City of Sumter Design Review Board

HP-26-13, 109 Dugan St. (City)

I. THE REQUEST

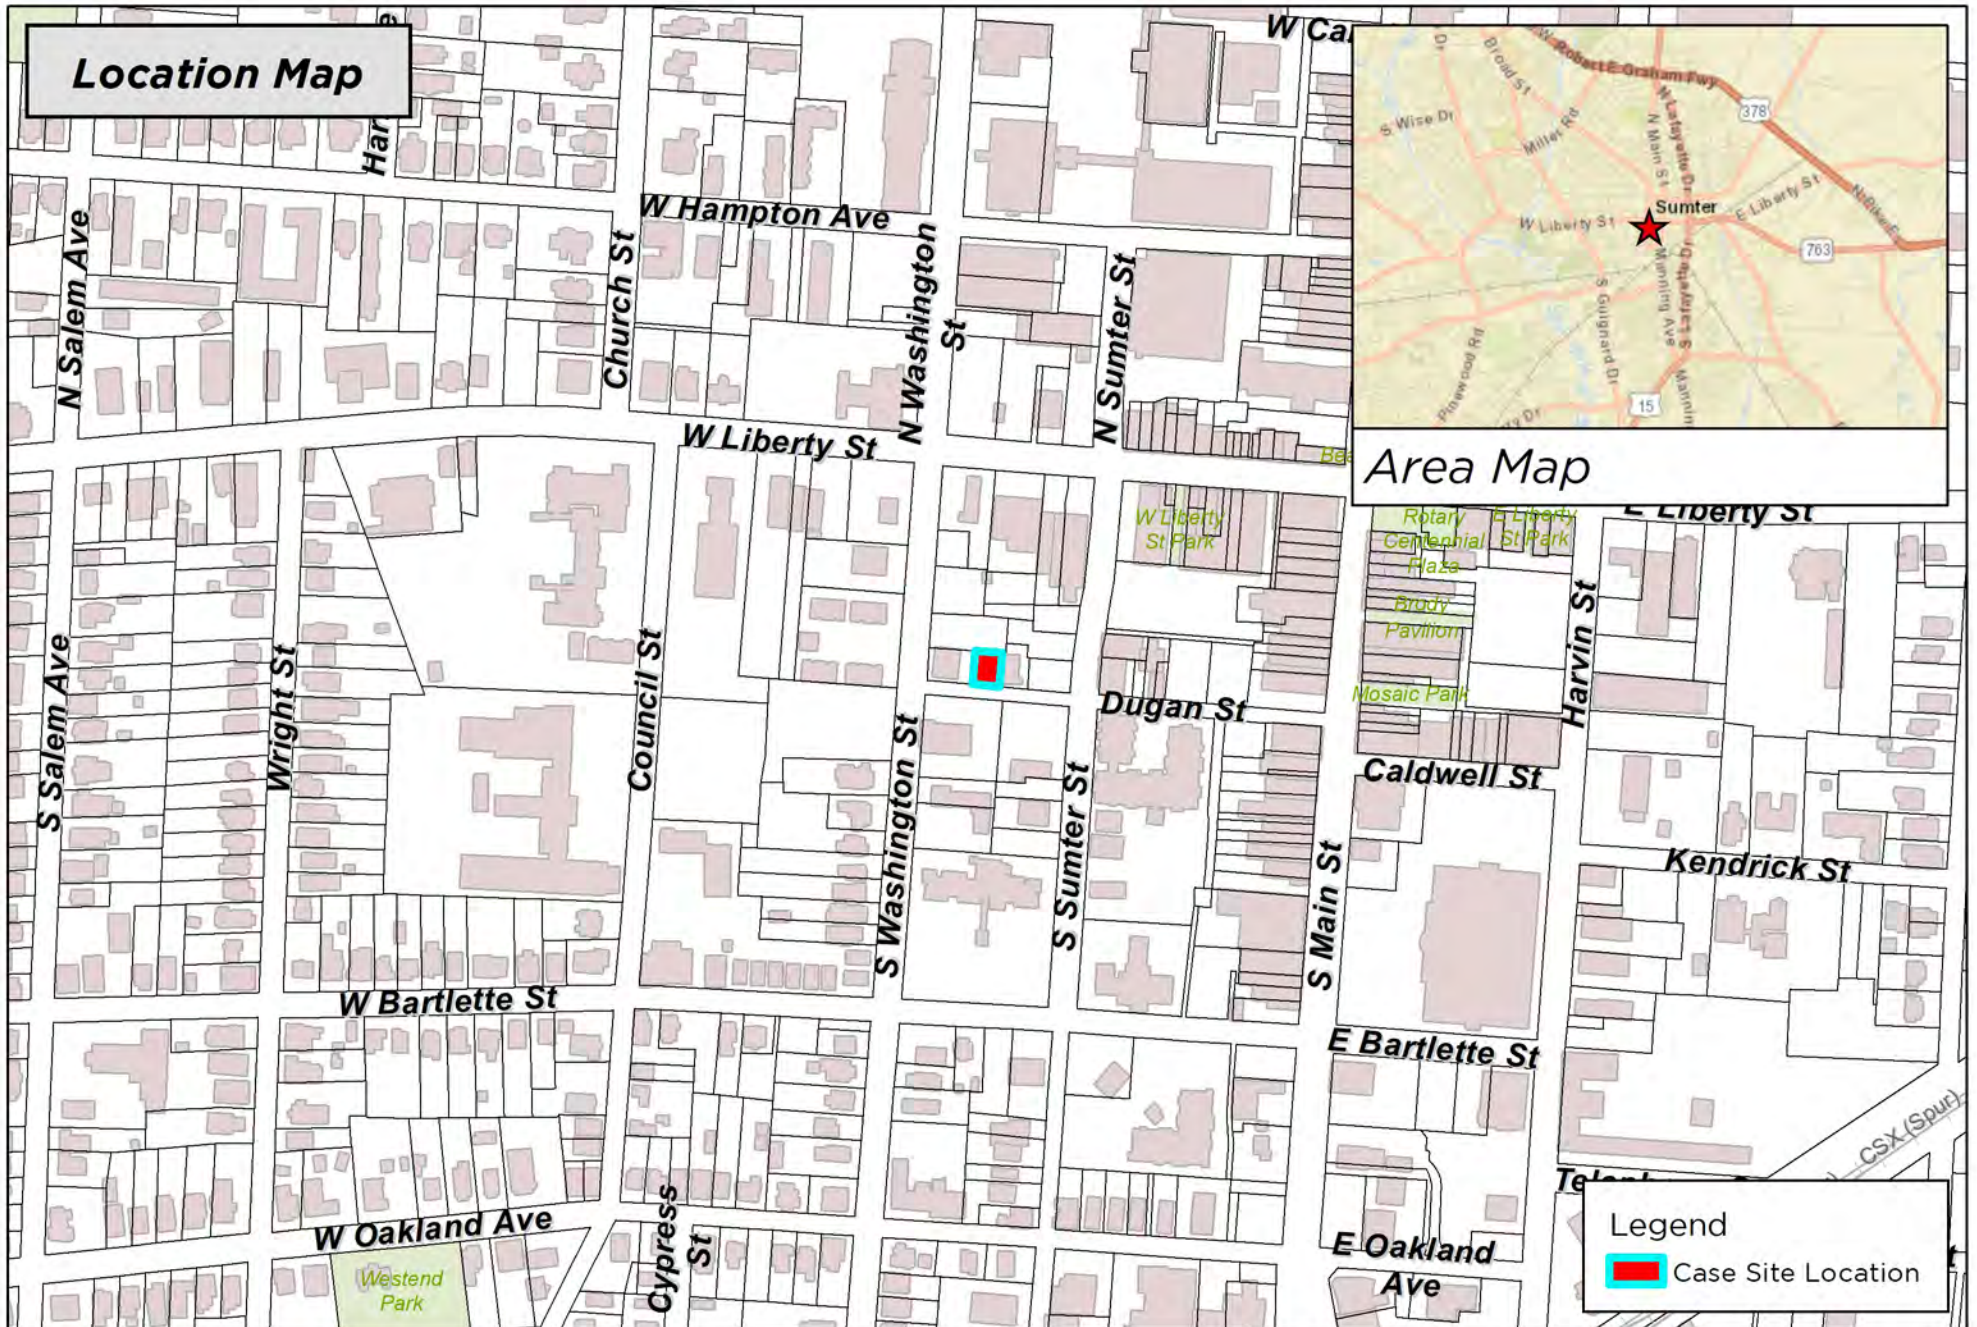
Staff is **supportive** of this request.

The proposed replacement of the material with fiber cement siding alternative is consistent with the design guidelines and will not detract from the Downtown Core District.
